DESCRIPTIVE REPORT

Registry No. H-10238

Sublocality Swanson Harbor and Vicinity

Descriptive Report
to Accompany Hydrographic Survey
H-10238 (Field No. FA 10-1-87, Scale 1:10,000)
NOAA Ship FAIRWEATHER S220
Captain John W. Carpenter, Commanding
1987

CHART
17316

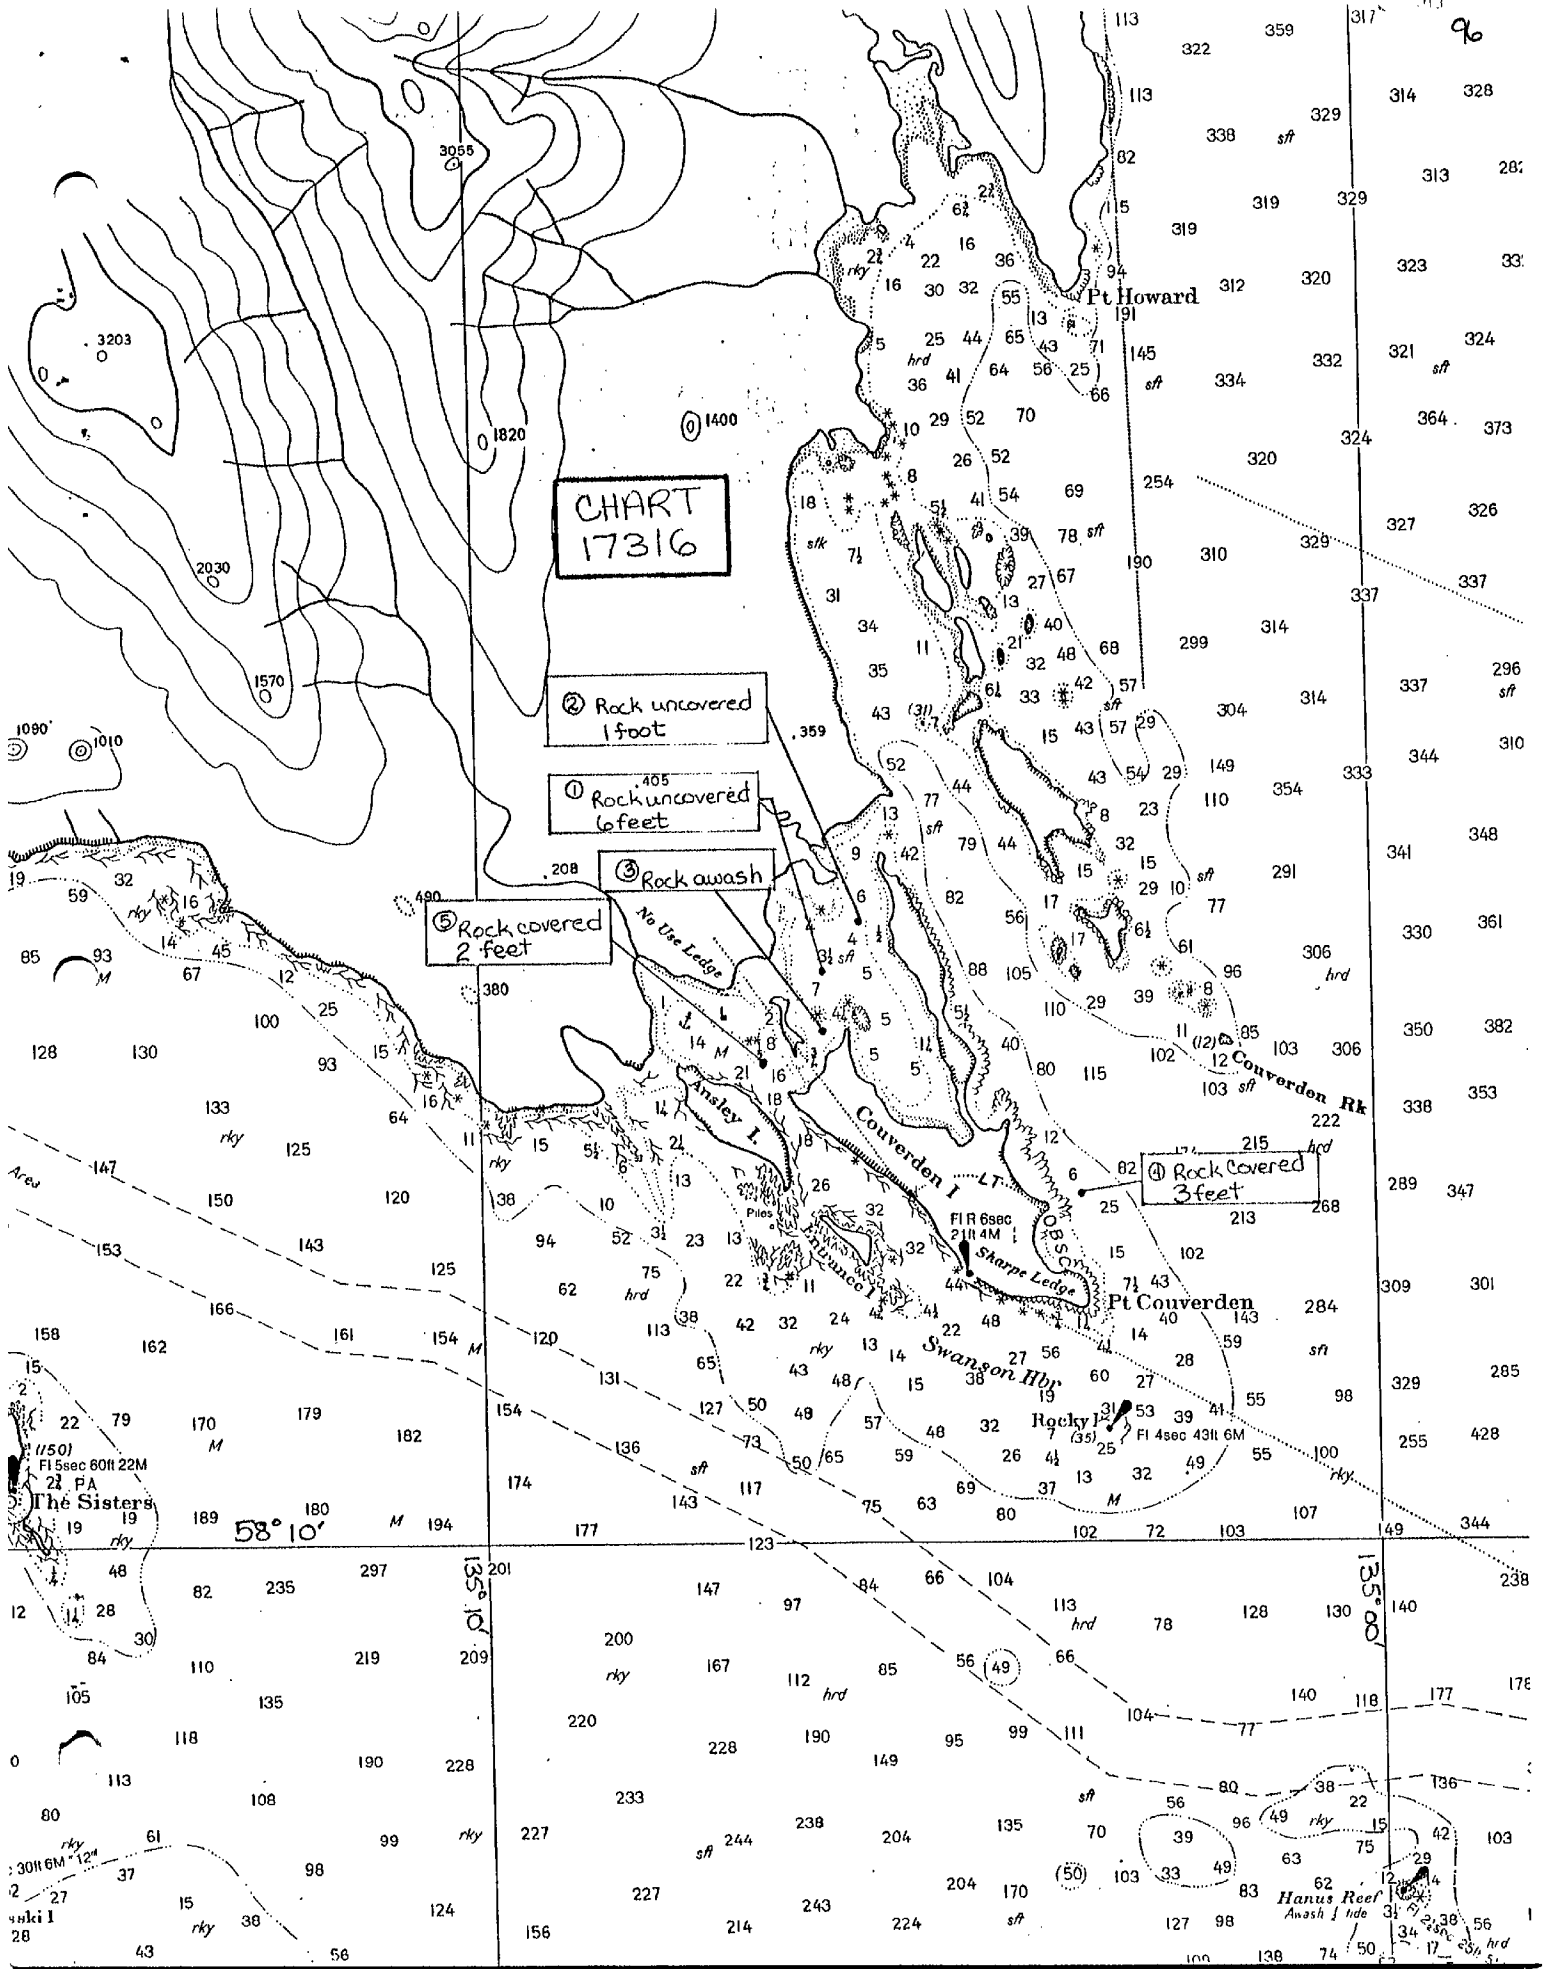
② Rock uncovered
1 foot

① Rock uncovered
6 feet

(VESNO 2023 DN123 Pos #1904-1912)

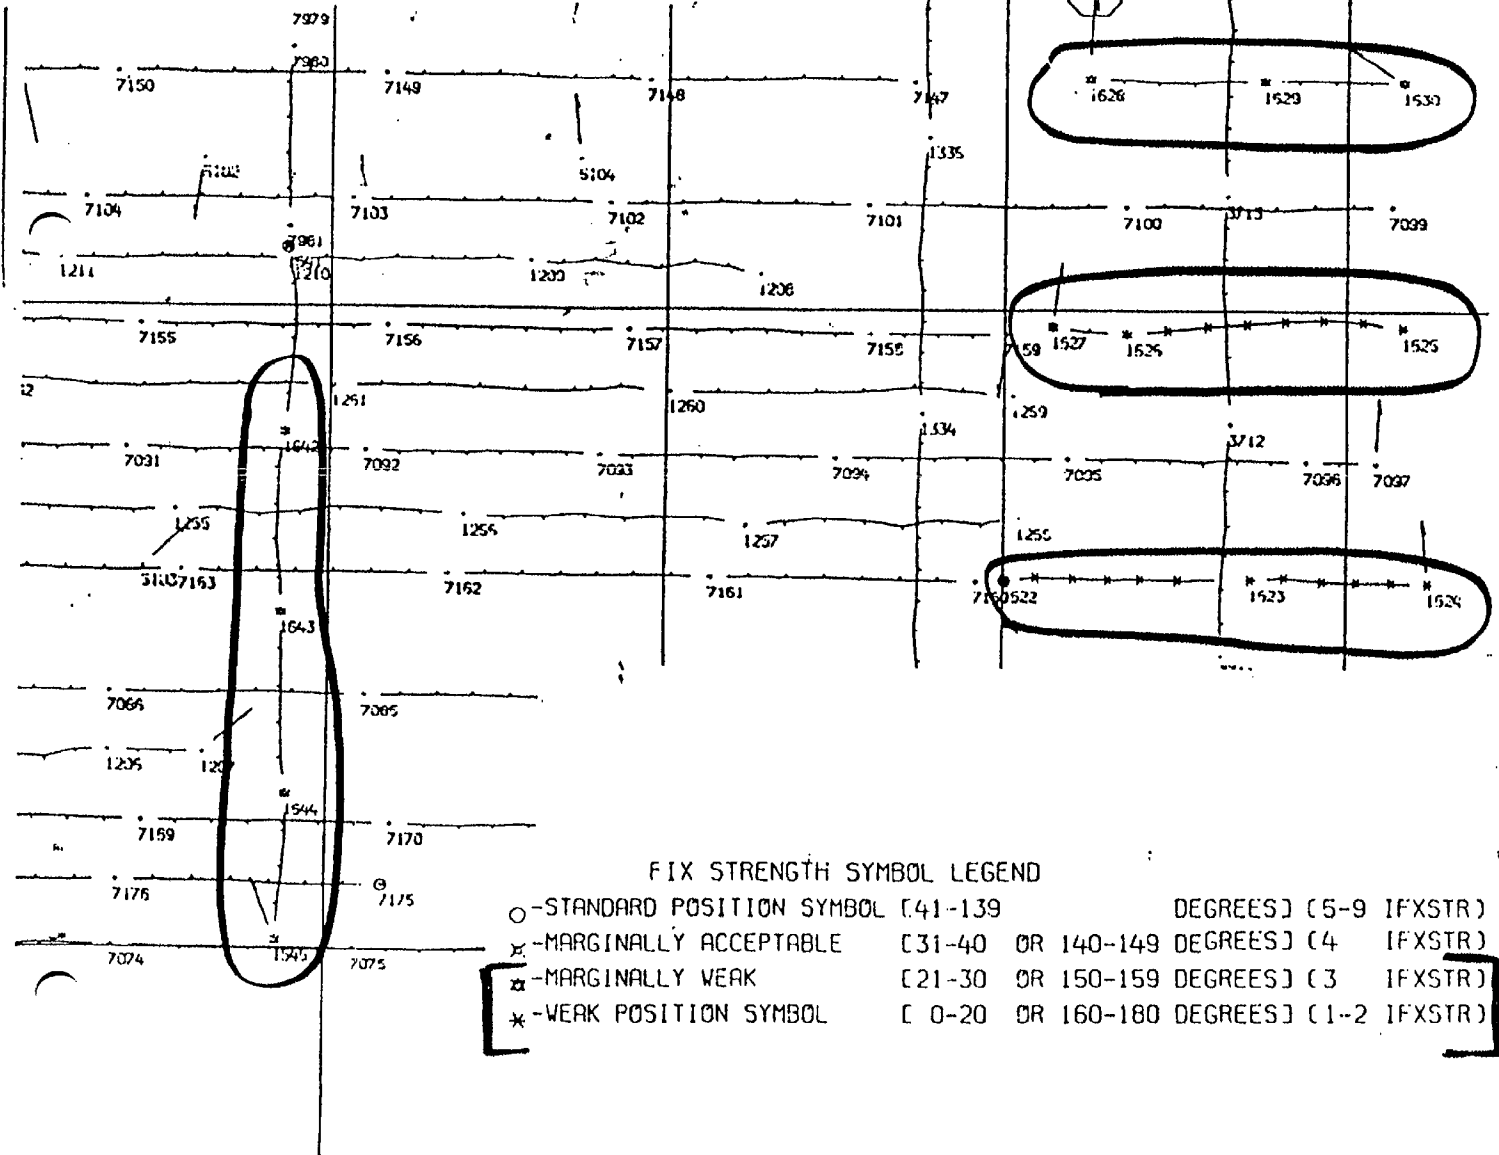
a. Data acquired on DN 125 were originally collected as range/range data with theodolite directions also being noted on the printouts. It appears that the master tape was recut using the theodolite directions, transforming the data into a range/azimuth format. During the change, the "042" code denoting range/range data within one of the day records of the master tape was not changed to the "110" code (denoting range/azimuth data).
